**PRODUCT NOTICE**

**Firmware Version 3.001 for 1715-AENTR  
May Not Update Outputs After Loss of Communications**

Reference: 2017-06-001

Date: June 2017

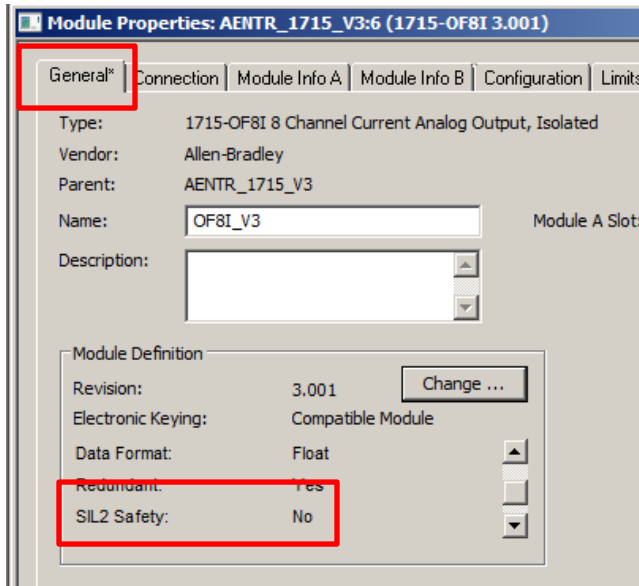
Using RSLinx, RSLogix 5000, or Studio 5000 when online, browse the network tree to find the 1715-AENTR module. Right mouse click on the module and select the Properties option. This will bring up the Module Properties dialog. Select the Module Info tab. The module's firmware revision level will be shown in the Revision field.

**Important** – Do not use the Revision field on the General tab to obtain the module's installed firmware version.

In the example shown to the left, the product code is 1715-AENTR and the firmware revision is 3.001. If the system is configured for non-SIL2 this module would be affected and subject to the actions of this notification.
